WATER PERMIT NO. 6871-3

Application For Permit To Appropriate Water For Irrigation

RE: Proposed Irrigation Dam
Platte Colony, Charles Mix County
DEC Project #21001

PLATTE COLONY IRRIGATION DAM PLANS AND SPECIFICATIONS ISSUED MAY 30, 2007

DAM PLAN

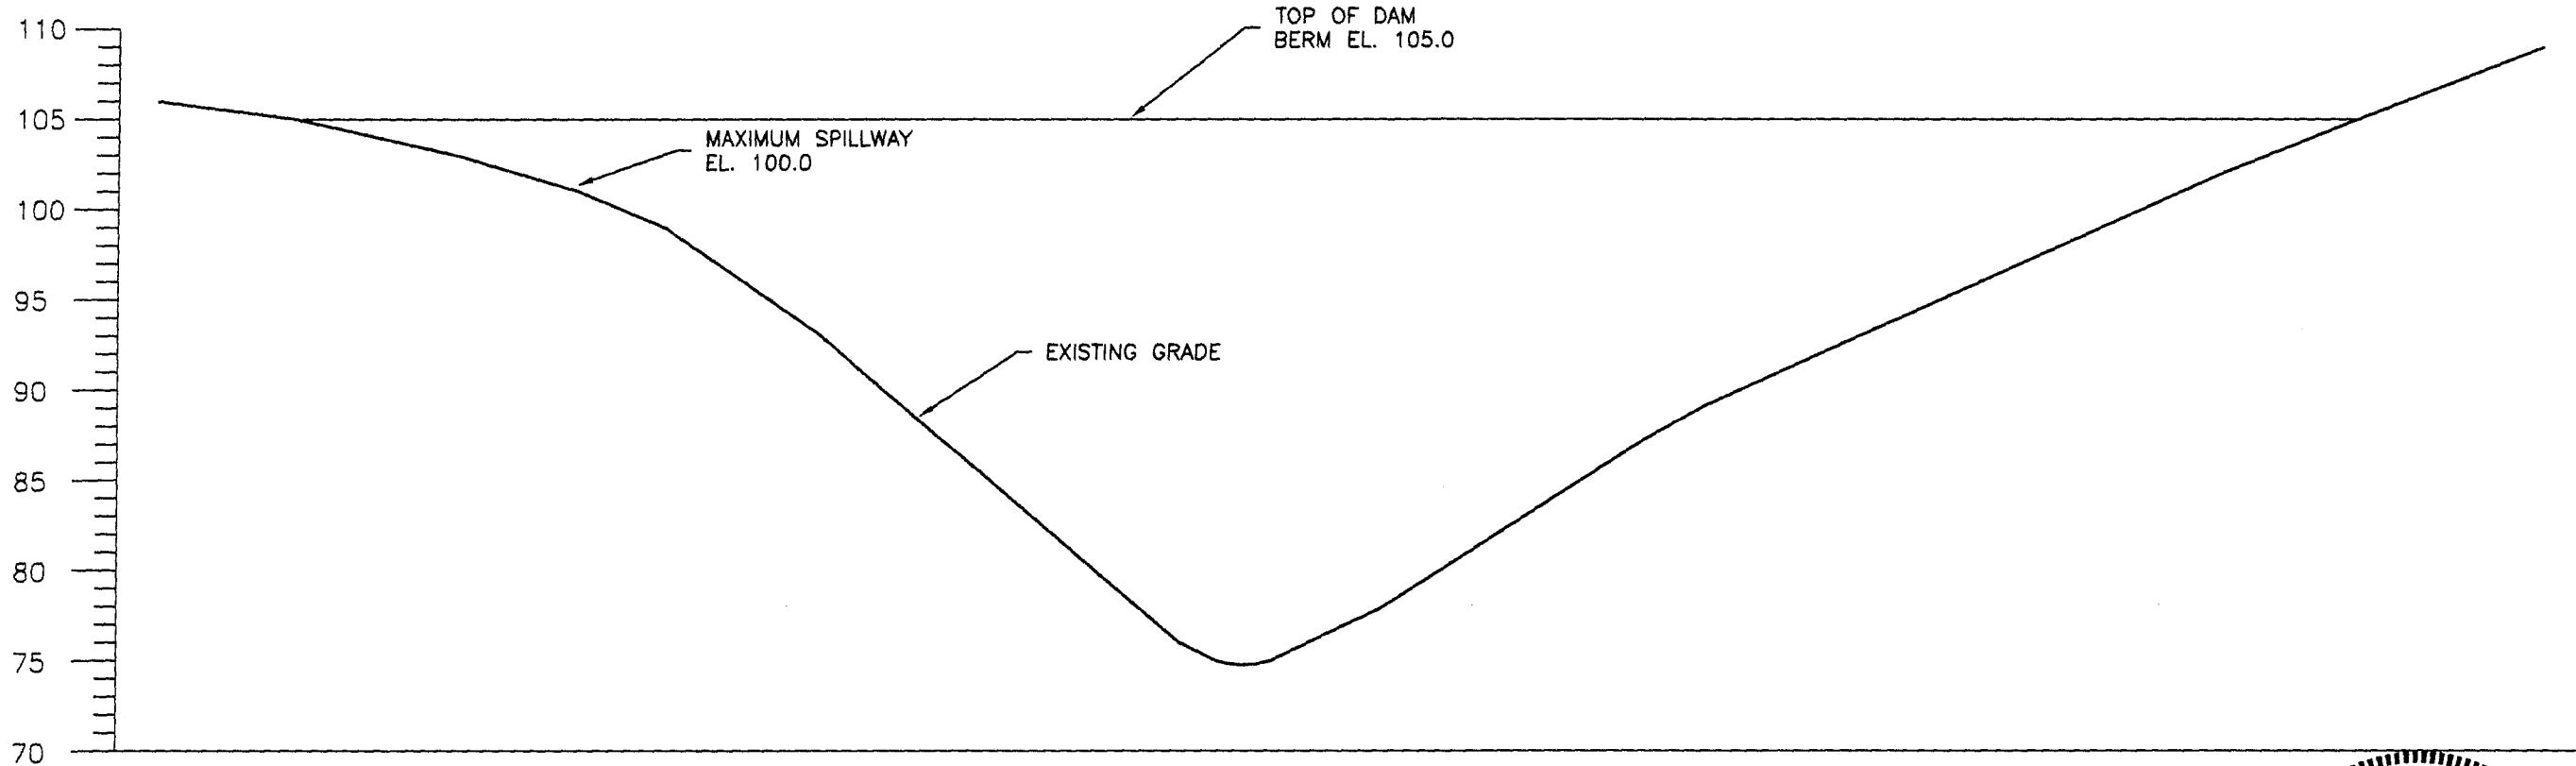
As we discussed, there are several changes to the plans that I would like to see before approving them. The secondary spillway should be moved off of the embankment grade and we discussed possibly constructing an earthcut spillway through the hillside to the east of the embankment. You will, more than likely, need fill material for the embankment and cutting the spillway would provide that. The other changes were associated with the primary spillway drop inlet structure. Typically the riser and barrel diameters are a different size, with the barrel diameter being one or two pipe sizes small than the riser, allowing for a better fit. I suggested getting some ideas regarding that from a pipe supplier. Another concern associated with the primary spillway structure would be the cutoff or seepage collar. Your design did not indicate what you had in mind there. We discussed using something similar to what the NRCS has been using.

Please consider these design changes and resubmit another set of plans for approval. Another issue I forgot to mention on the phone is Hazard Classification. Please indicate the Hazard Classification the dam is designed for. If you have any questions, please feel free to let me know.

ANTISEEP COLLAR DETAILS

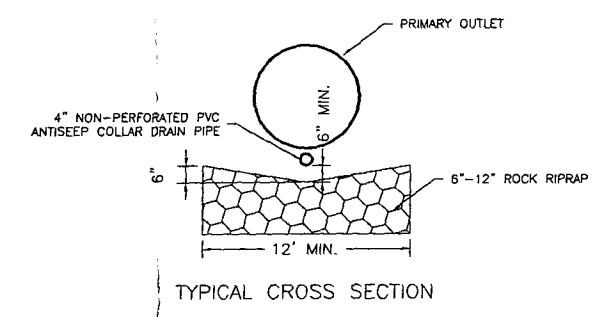
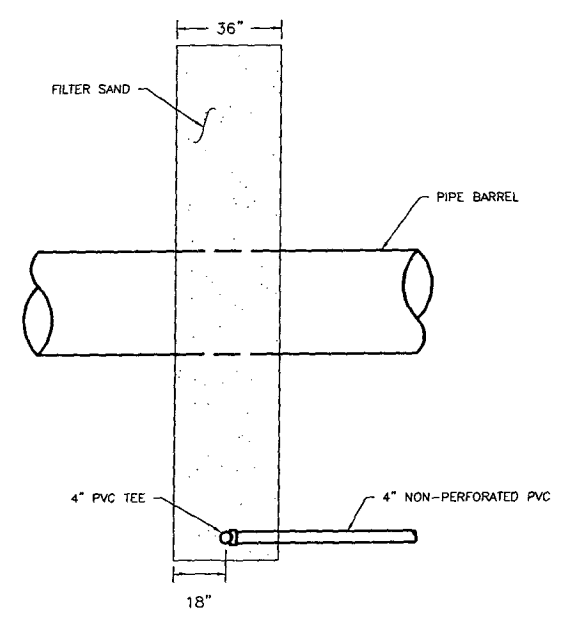
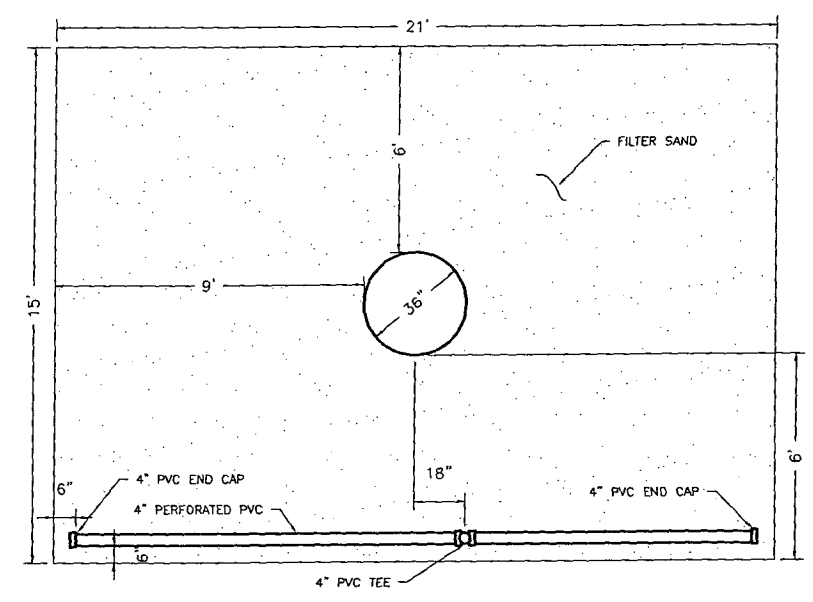
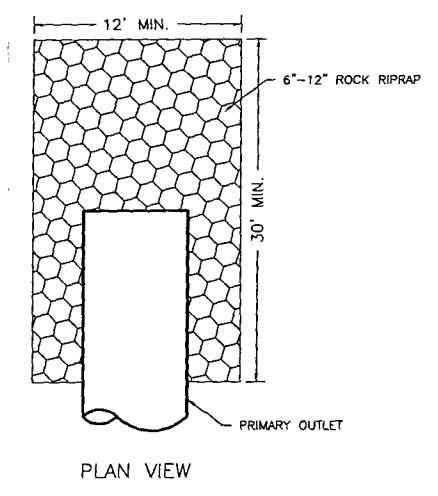
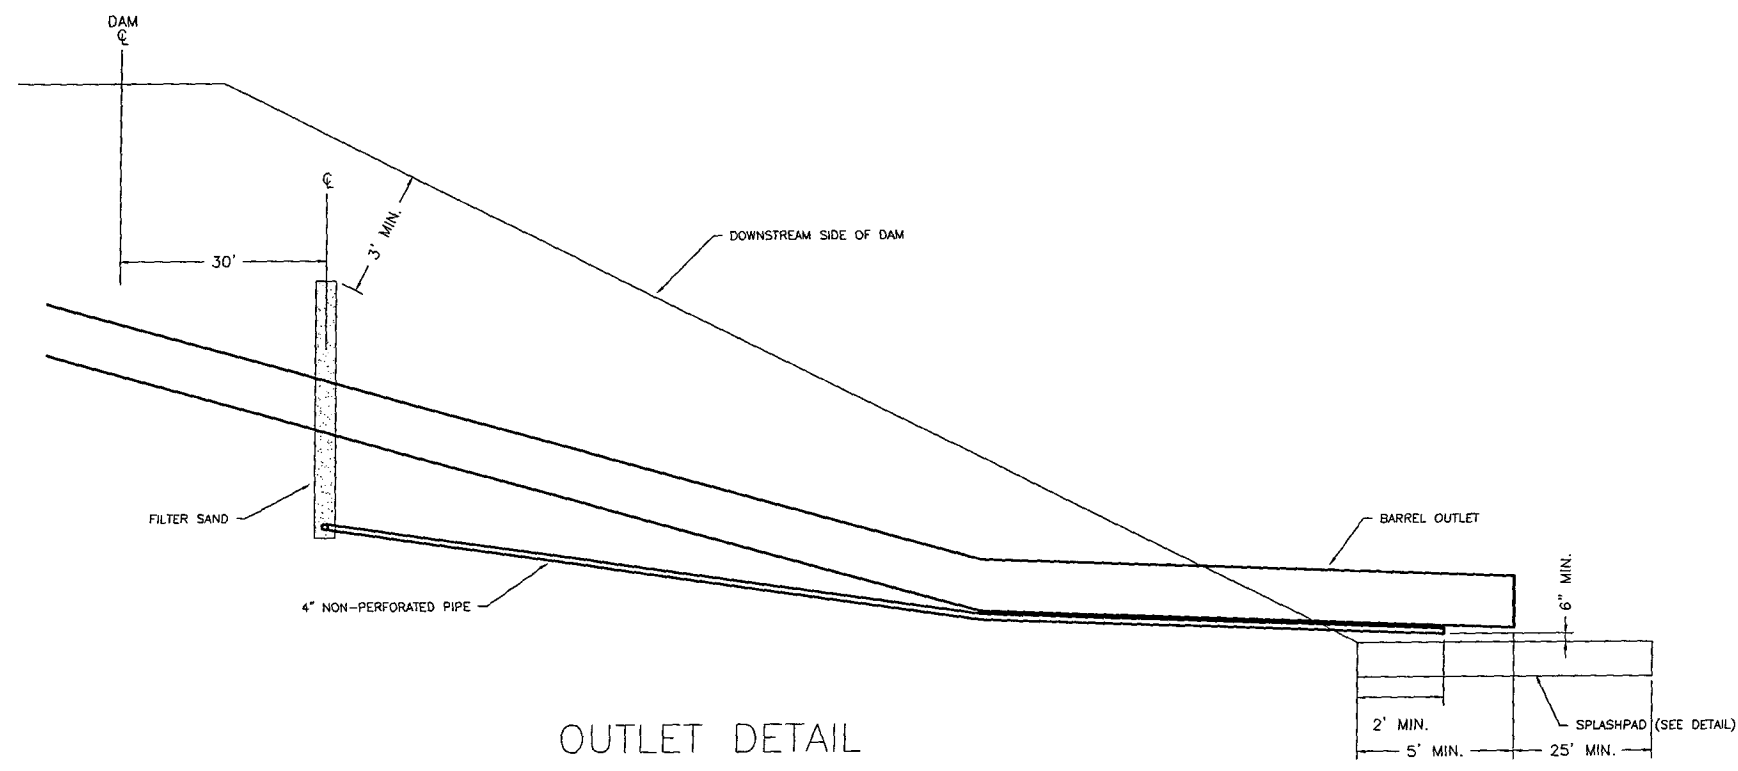
Enclosed are a set of "As Built" plans for a dam recently constructed by the NRCS, showing the secondary spillway configuration and their sand anti seep collar (Job Plan 3.8). Also enclosed is what they have recently switched to and referring to it as a sand filter diaphragm (Job Plan 3.8-B). Either of these designs would be okay with us.
